November 22, 2019

Re: Docket No. 70-925; License No. SNM-928  
License Amendment Request to Redefine the Licensed Area

ATTACHMENT 1  
FIGURES 1 THROUGH 3

#### Figure 1 – Licensed and Controlled Areas in the Western Area

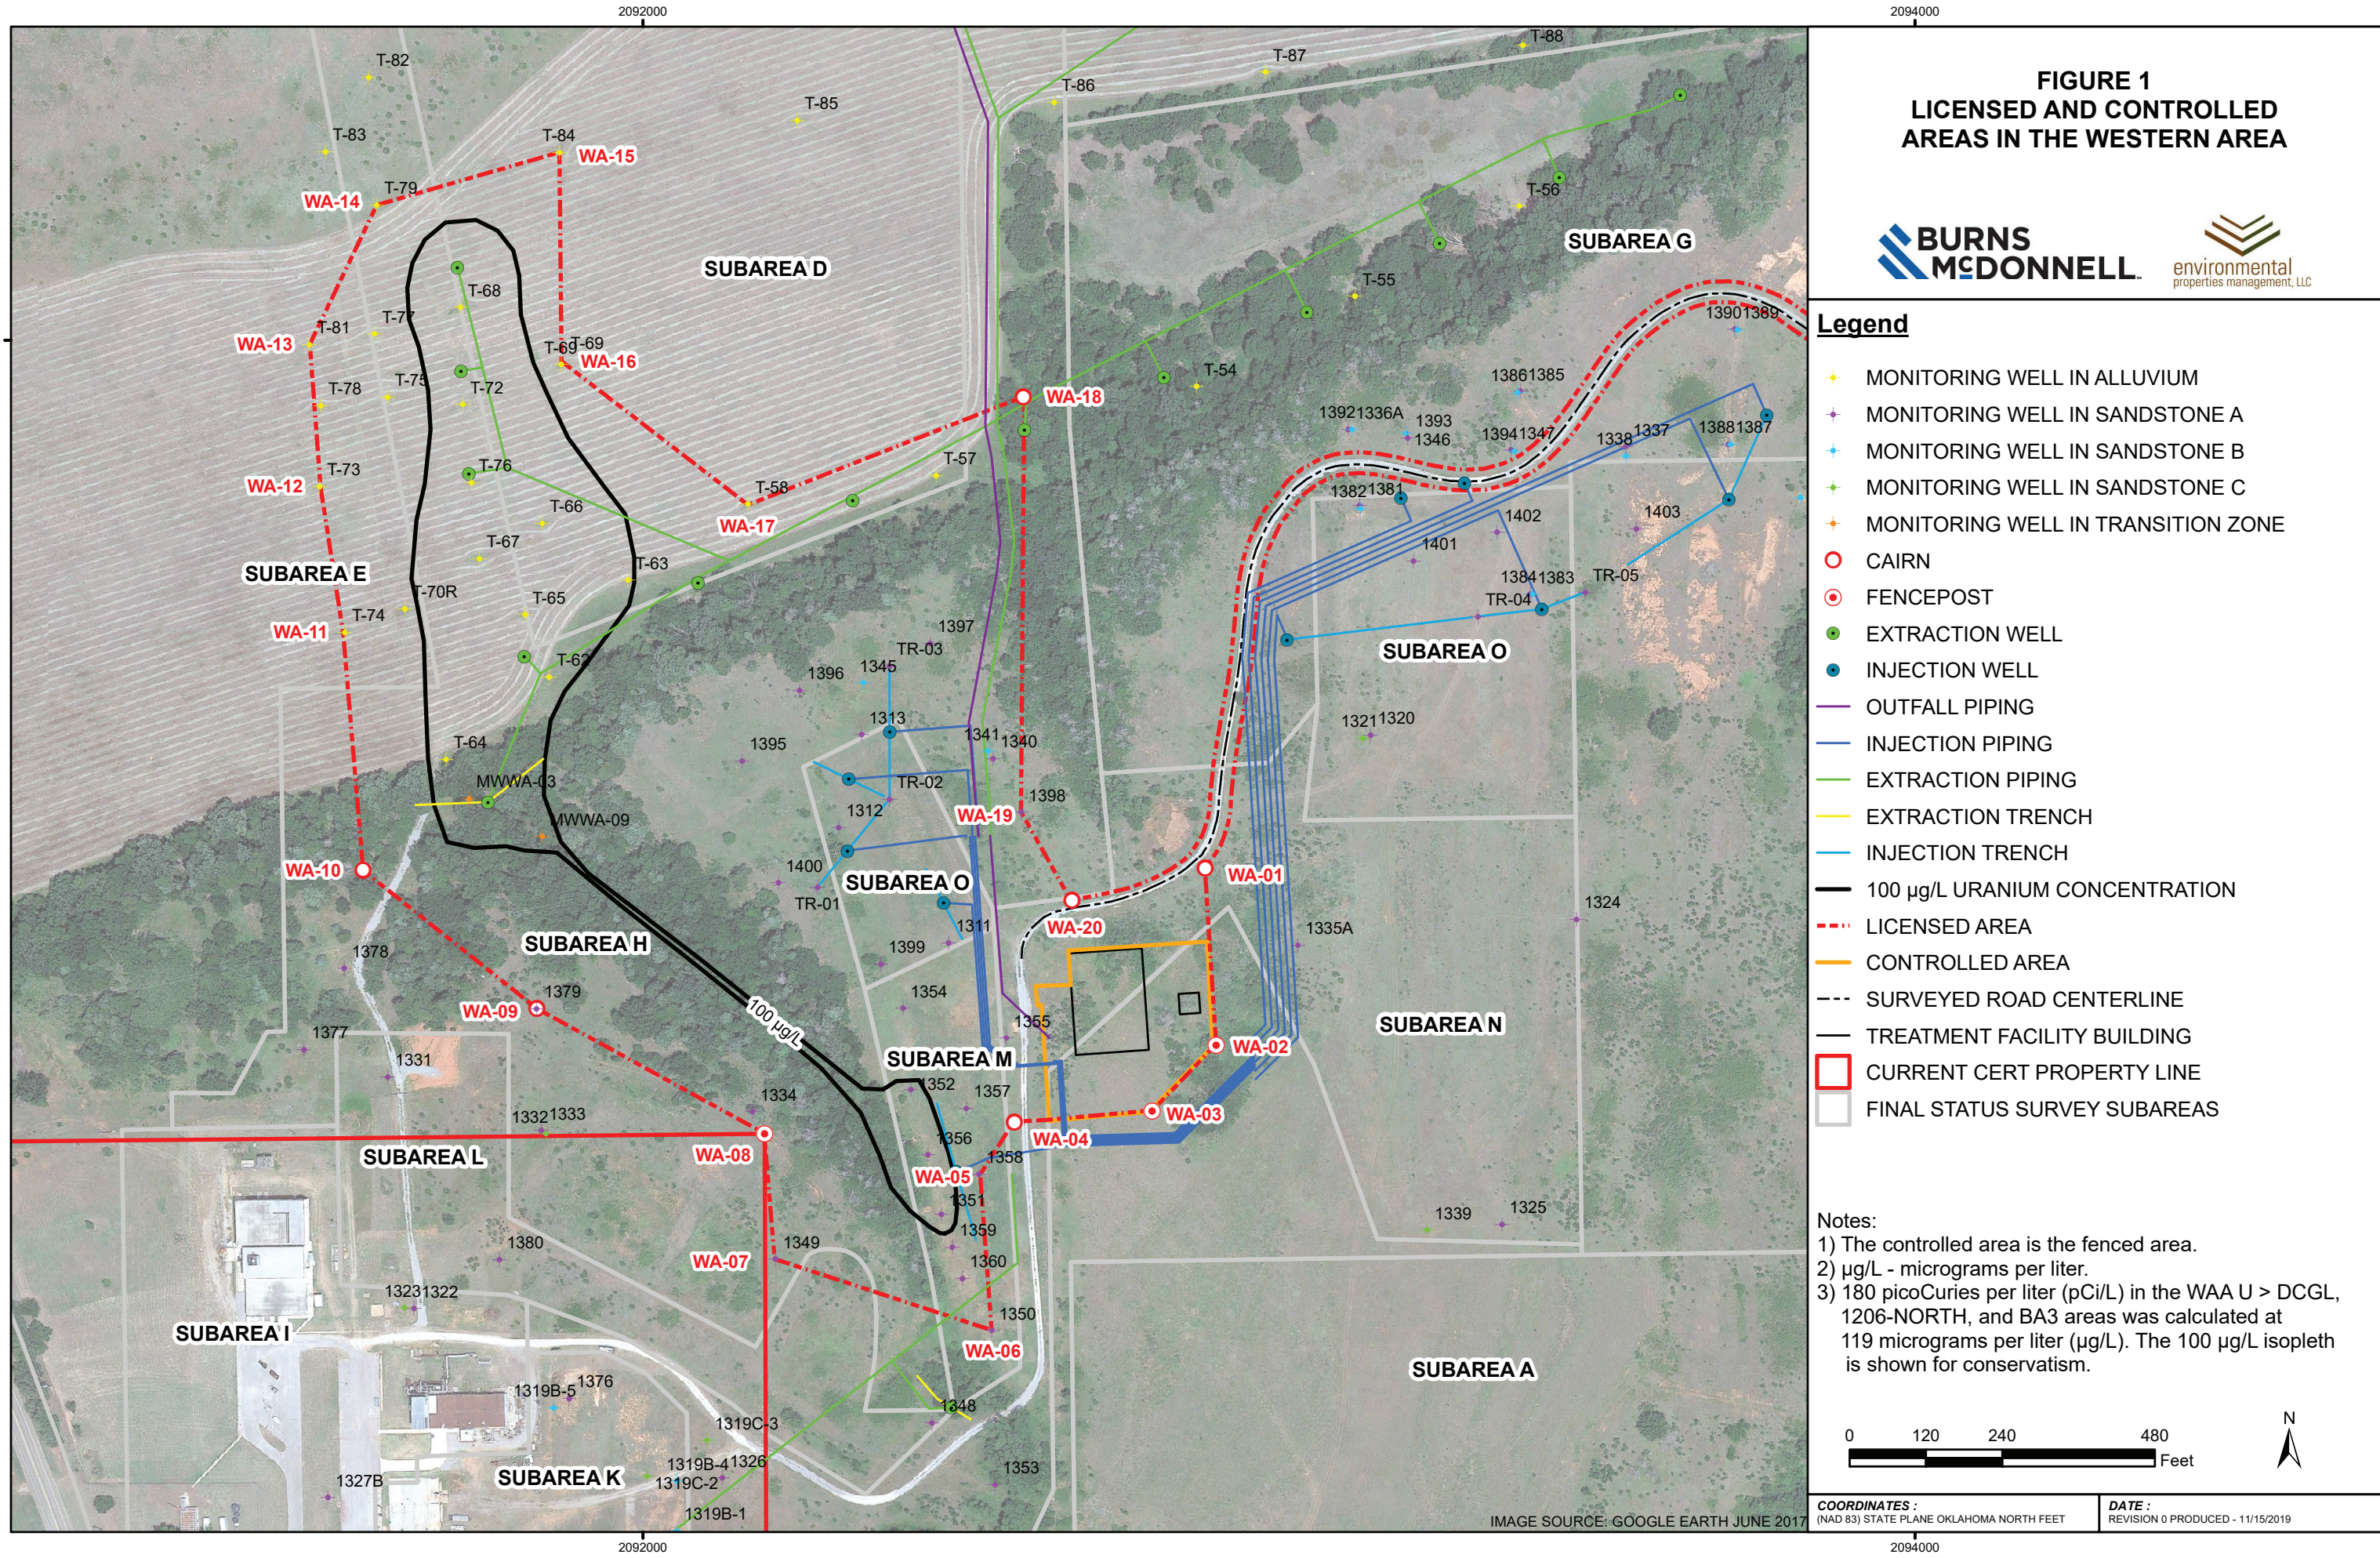
Figure 1 depicts the licensed and controlled areas in the western portion of the Site. A black isopleth depicts the area within which uranium concentrations exceed 100 micrograms per liter ( $\mu\text{g/L}$ ). The U-235 enrichment in this area varies, and 100  $\mu\text{g/L}$  is the lower concentration than would yield a total uranium activity of 180 picoCuries per liter ( $\text{pCi/L}$ ) at the highest conservatively estimated enrichment. Consequently, the black line represents a greater area than the area within which groundwater containing uranium exceeding the decommissioning criteria is present. The red dashed line extends beyond this area, providing additional “buffer” around the area within which groundwater contains uranium exceeding the decommissioning criteria.

The area within the red dashed line also includes the area in which piping will transport groundwater in which uranium exceeds the decommissioning criteria and the roadway over which vessels of spent resin will be transported from BA1 to the WATF.

The area bounded by the solid orange line represents the controlled area, and includes all areas within which:

- Groundwater containing uranium exceeding the decommissioning criteria is brought to the surface.
- Groundwater is treated to remove the uranium by ion exchange.

- Spent ion exchange resin is processed and packaged for shipment to a licensed disposal facility.
- Waste that contains concentrations of radioactive material requiring disposal as low level radioactive waste is stored or staged.

**FIGURE 2**  
**LICENSED AND CONTROLLED**  
**AREAS IN BURIAL AREA #1**

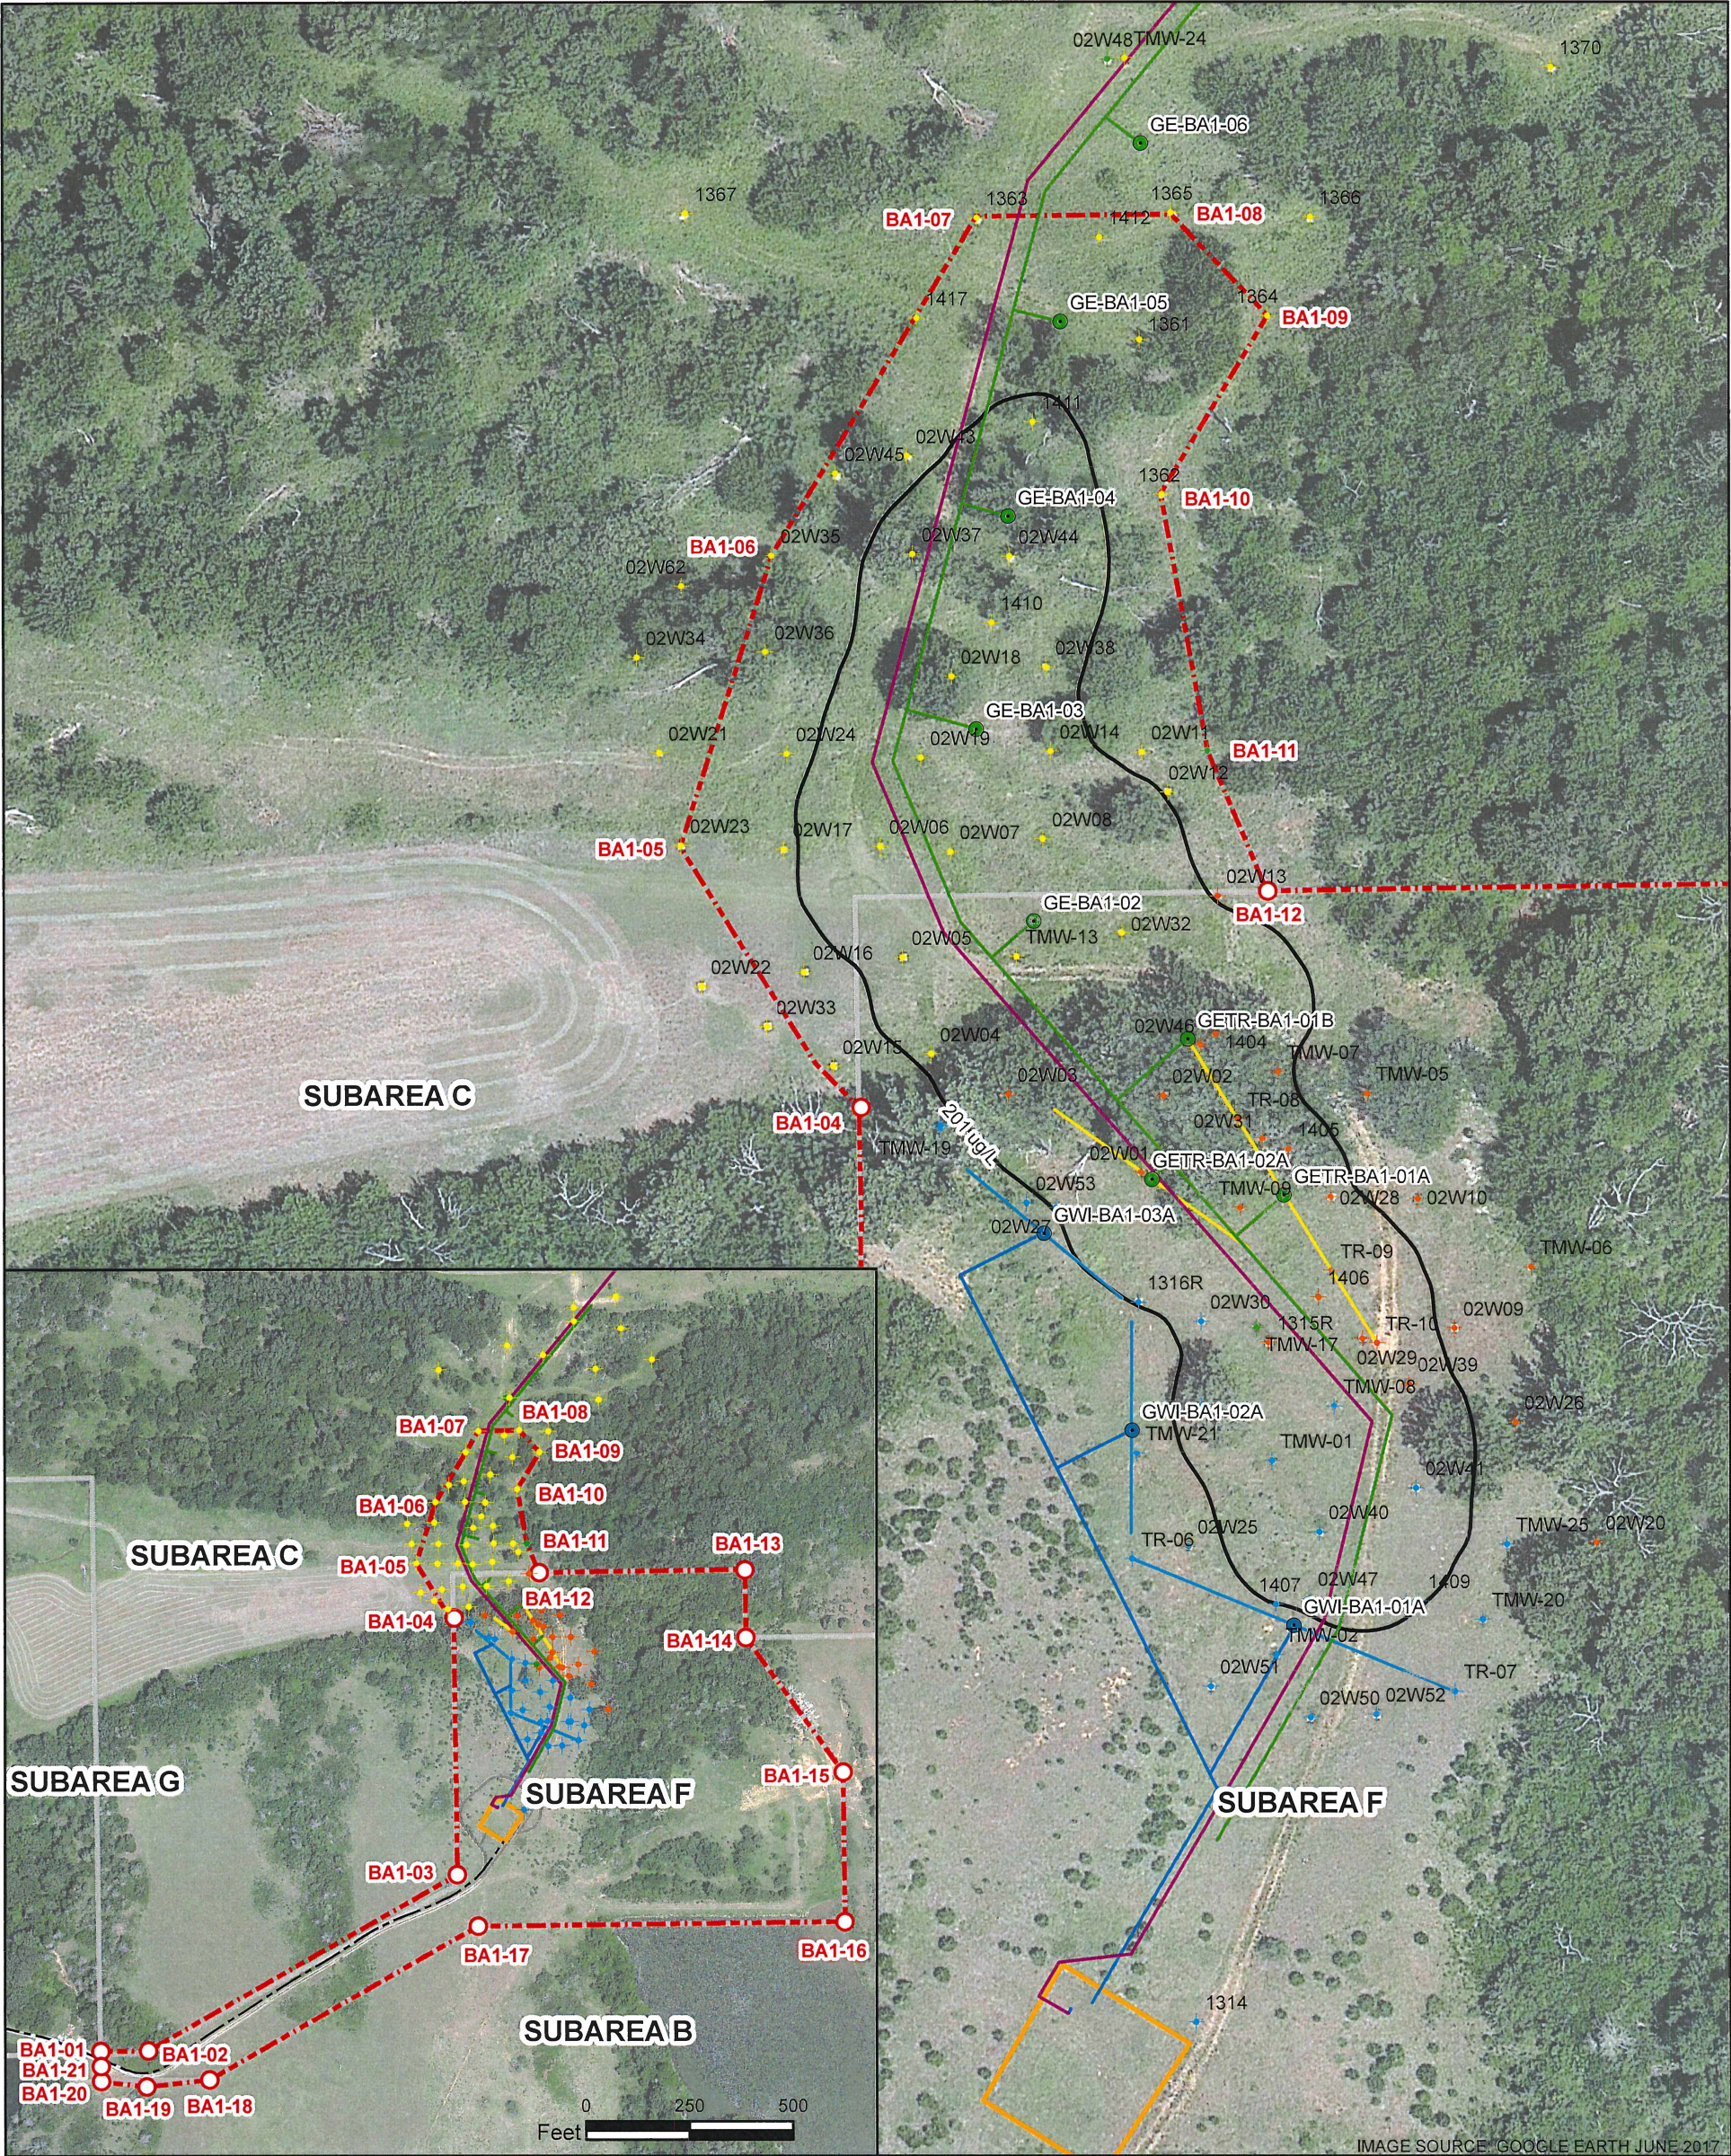
Figure 2 depicts the licensed and controlled areas in the eastern portion of the Site. A black isopleth depicts the area within which uranium concentrations exceed 201 µg/L. The conservative estimate of the U-235 enrichment in this area is 1.3%, and 201 µg/L is the concentration that would yield a total uranium activity of 180 pCi/L at that enrichment. Consequently, the black line represents the maximum potential extent of groundwater containing uranium exceeding the decommissioning criteria. The red dashed line extends beyond this area, providing additional “buffer” around the area within which groundwater contains uranium exceeding the decommissioning criteria.

The area within the red dashed line also includes the area in which piping will transport groundwater in which uranium exceeds the decommissioning criteria, the area within which groundwater will be treated to remove the uranium by ion exchange, and the roadway over which vessels of spent resin will be transported from BA1 to the WATF. This area also includes all of former Subarea F.

The area within the solid orange line is the controlled area, and includes all areas within which:

- Groundwater containing uranium exceeding the decommissioning criteria is brought to the surface.
- Groundwater is treated to remove the uranium by ion exchange.

Vessels containing spent resin will be removed from BA1 and transported to the WATF for processing, packaging, storage and shipment. Waste will not be stored or staged within BA1, except for incidental consumables such as gloves, filters, etc., that will be stored in a waste receptacle prior to transfer to the WATF; such waste will be transferred to the WATF at the end of each day.
